**• A D D E N D U M # 2 •**

<b>TO ALL PLAN HOLDERS</b>	<b>DATE</b>	<b>JULY 10, 2015</b>	<b>JOB NO.:</b>	<b>2302-023</b>
	<b>ATTN</b>	<b>Plan Holders</b>		
	<b>RE</b>	<b>City of Newport Ferry Slip Road Improvements</b>

1 PLAN STA 0+00 TO 4+50  
1" = 40'

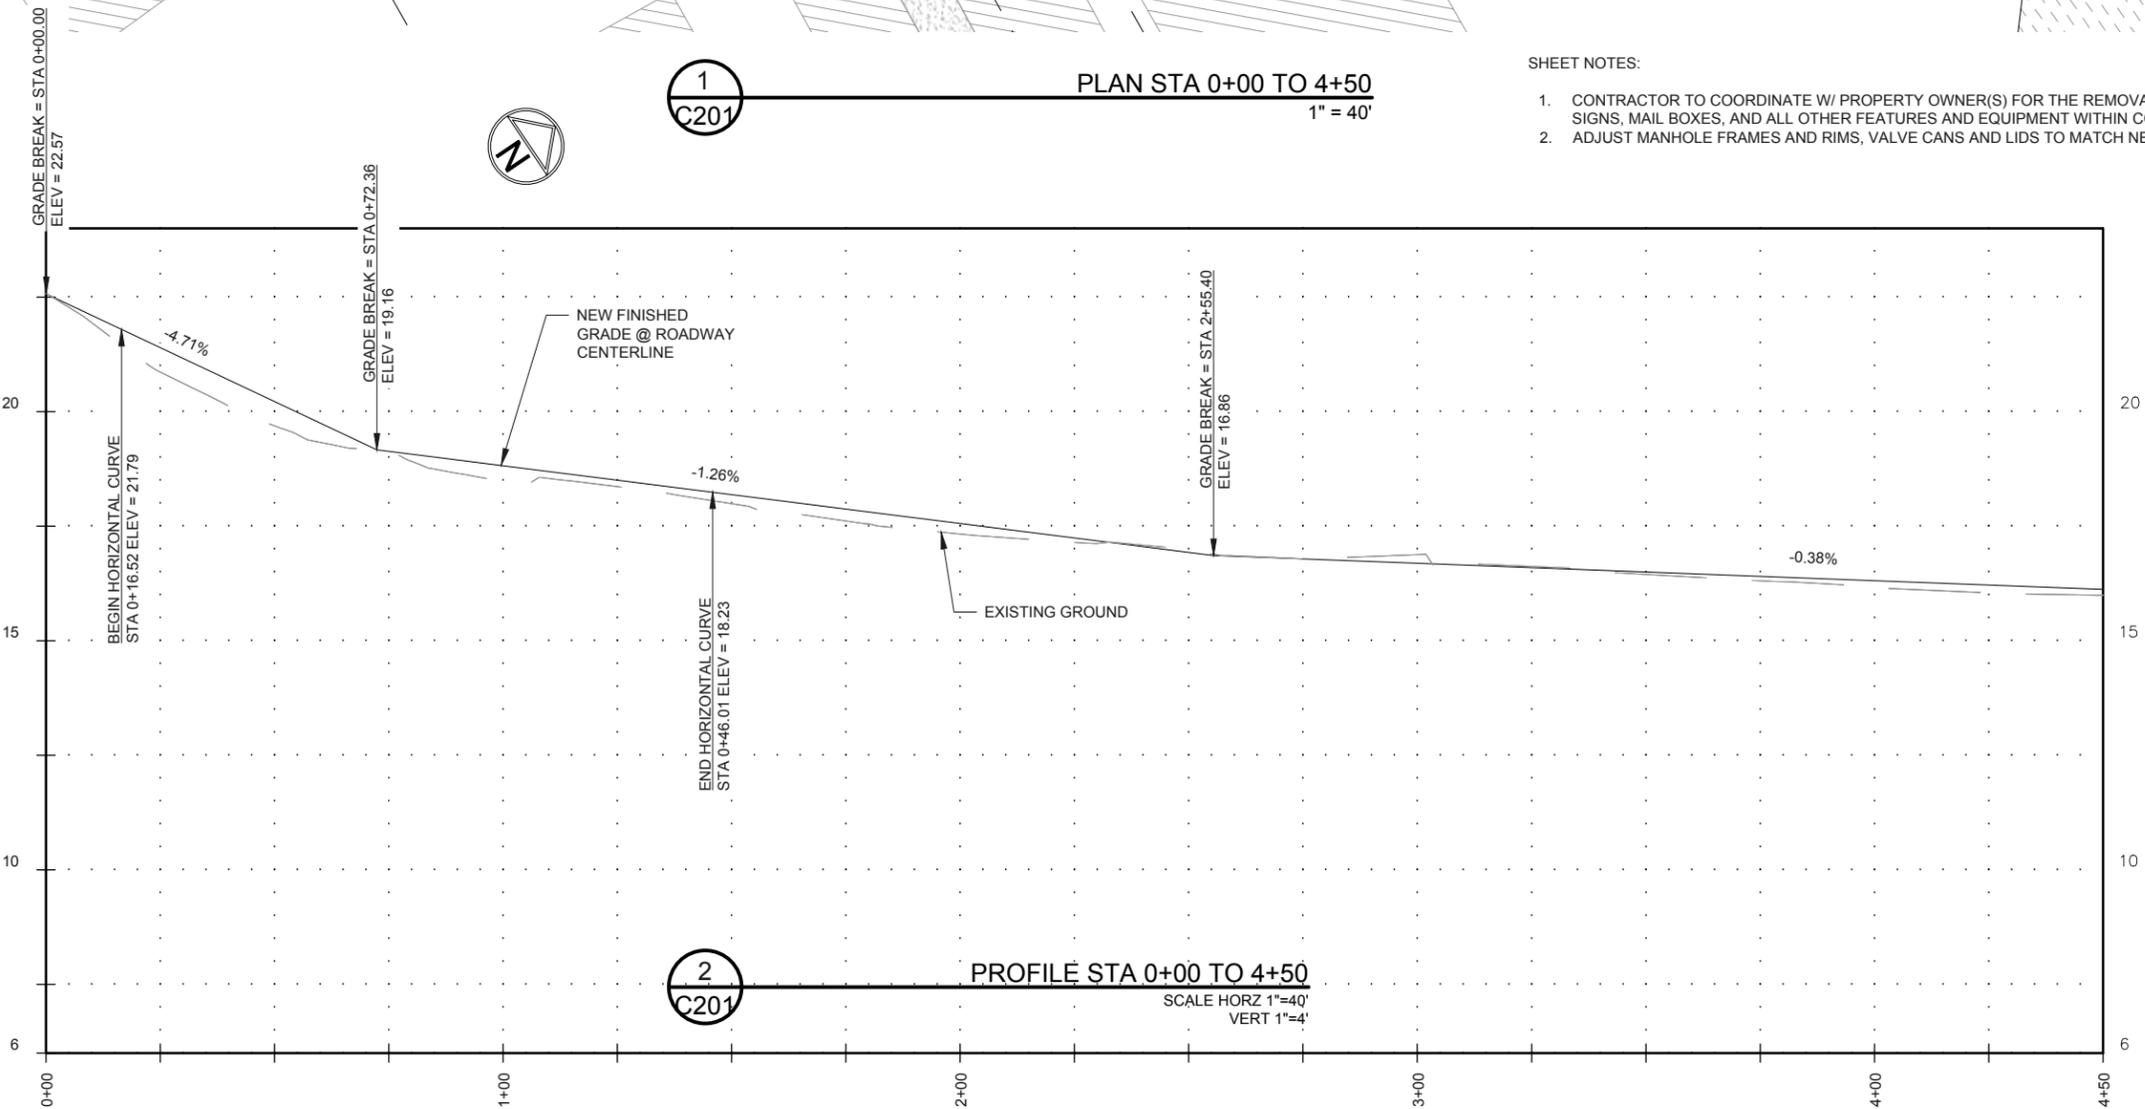
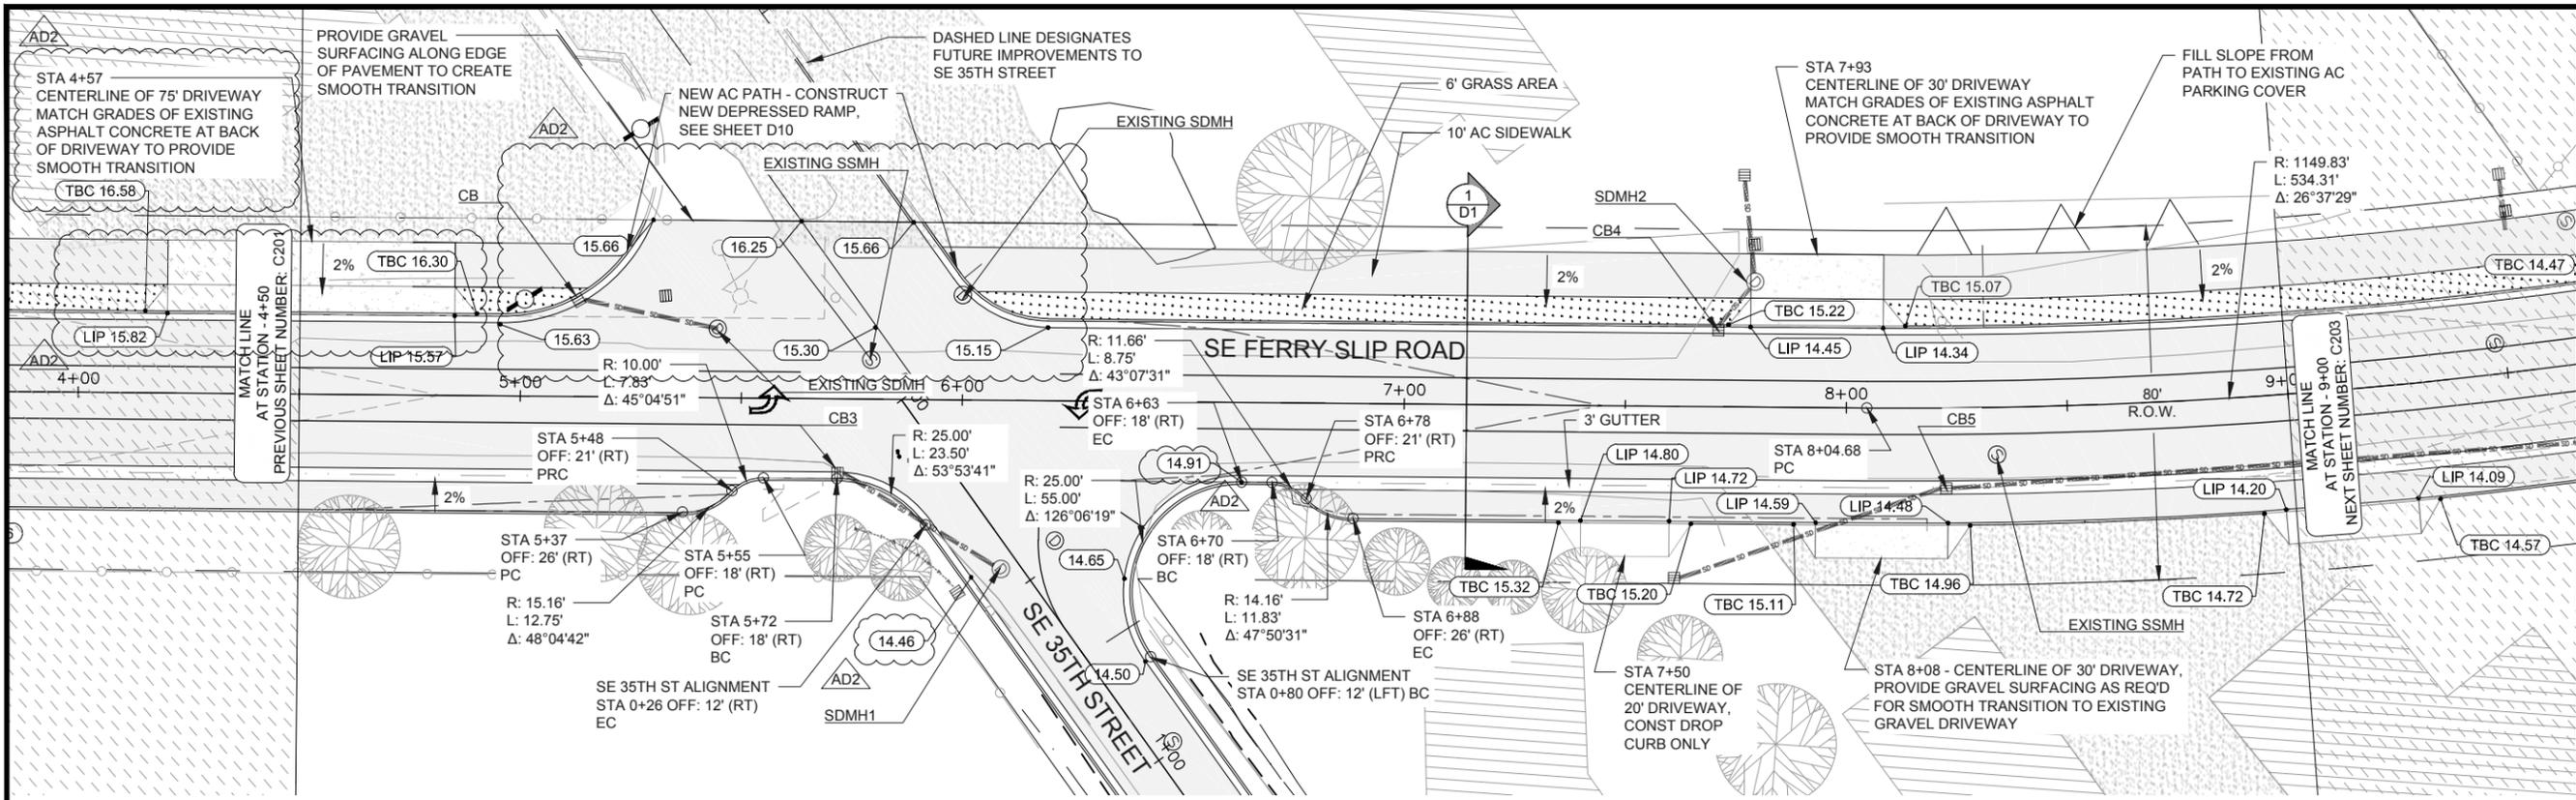
15. C004- Delete "END 2" GRIND" from "Sta 3+46 offset 18' rt..." callout.
16. C101- Add 5' AC pathway from Sta 0+00 to Sta 0+60.
17. C101/C201/C202- Increase driveway size to 75' and move to Sta 4+52.

1  
C202  
PLAN STA 4+50 TO 9+00  
1" = 40'

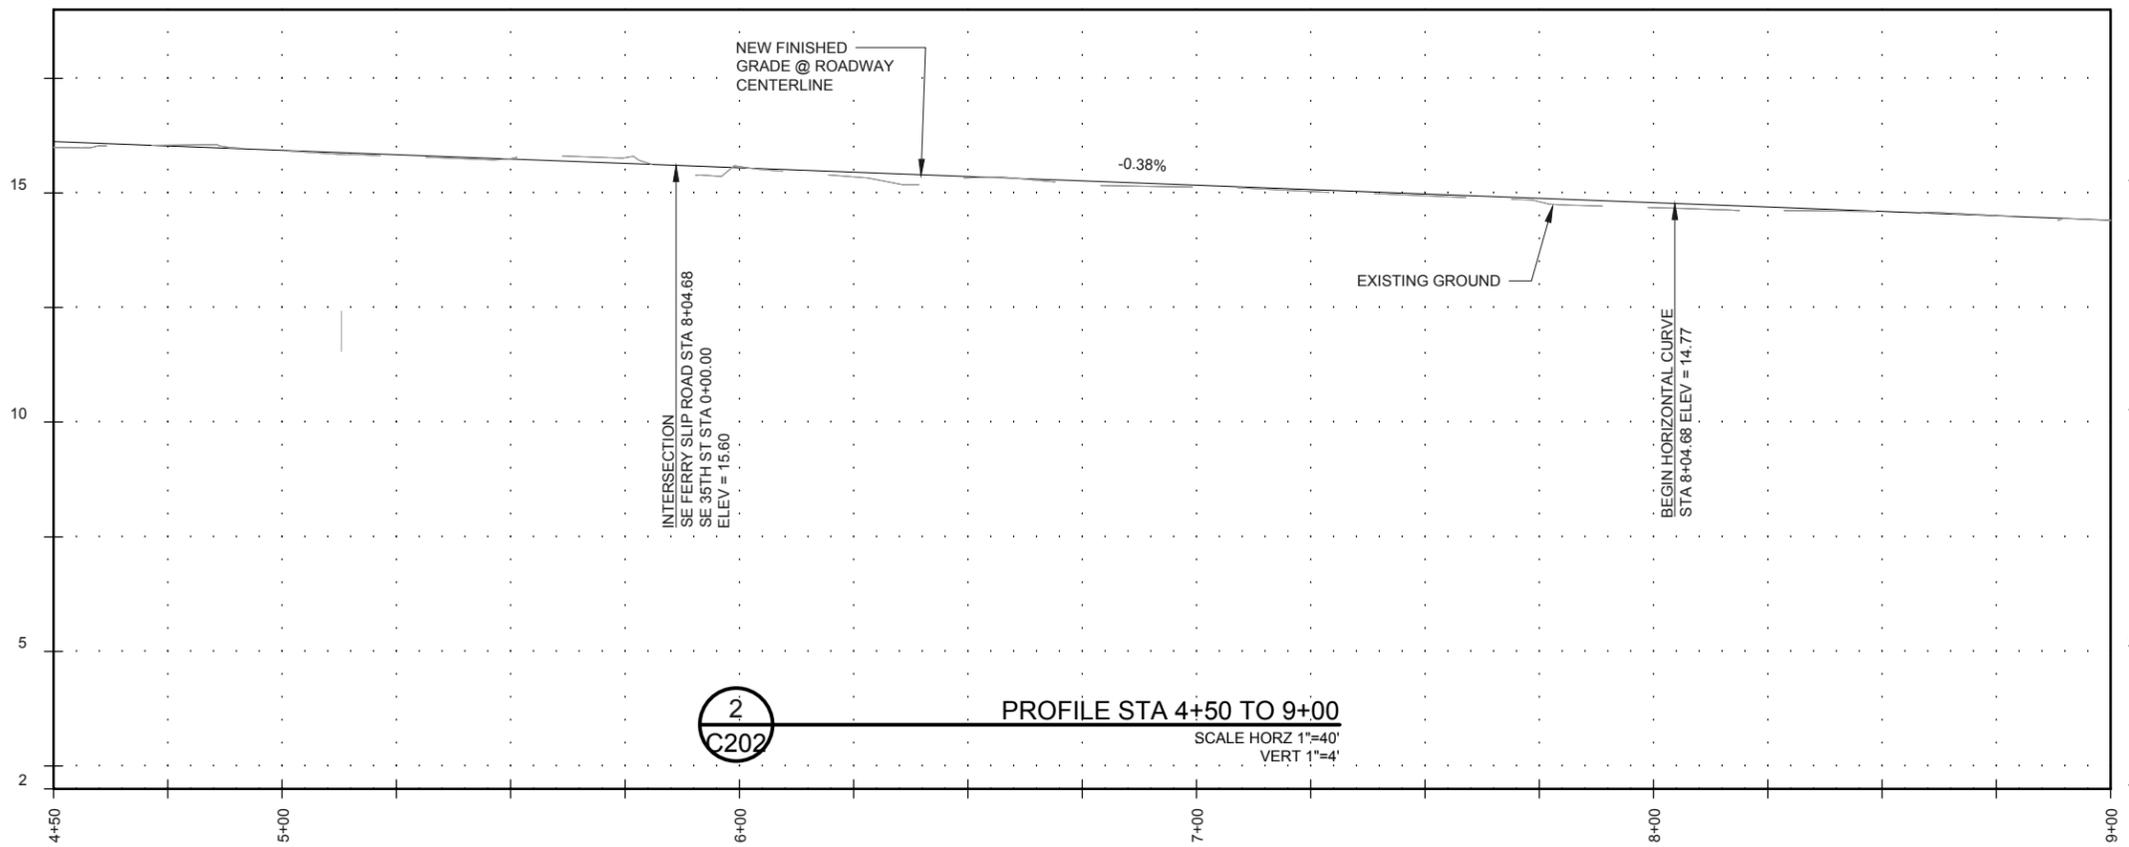
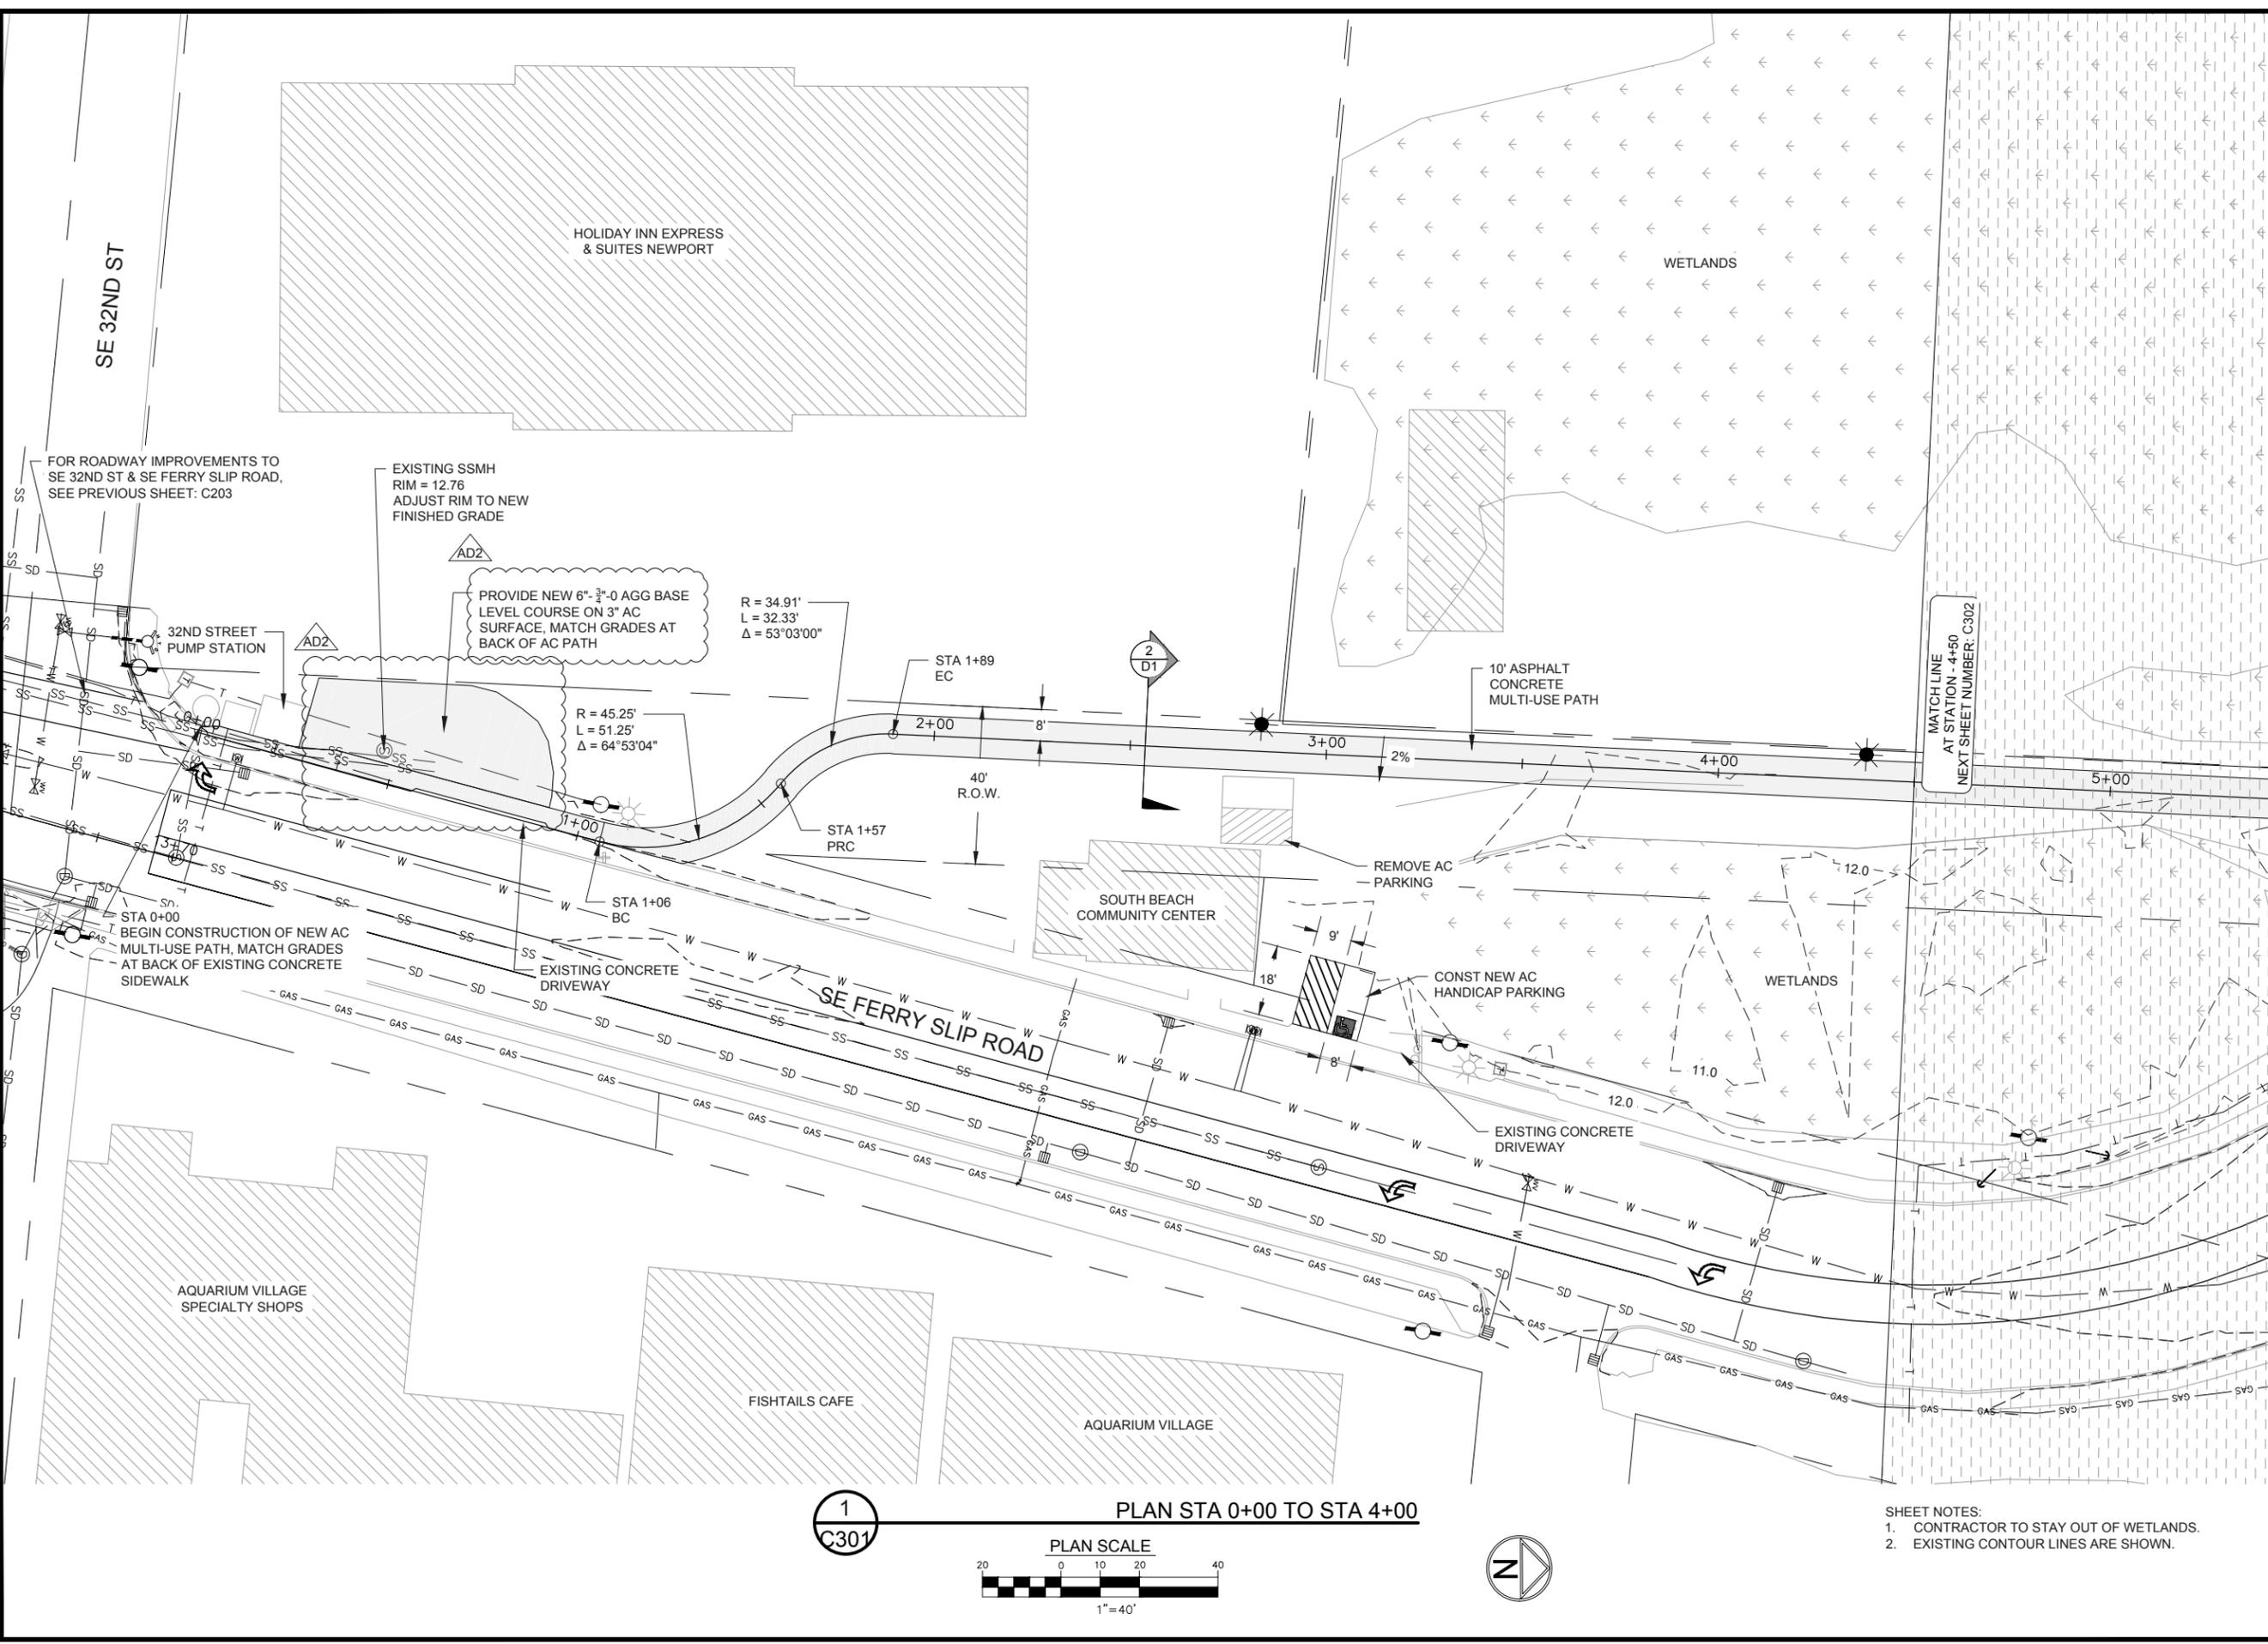
18. C102/C202- Extend curb and overlay at the intersection of SE 35<sup>th</sup> and Ferry Slip Rd (West Side).
19. C102- Add "BY OTHERS" to "remove and relocate existing power..." callout.
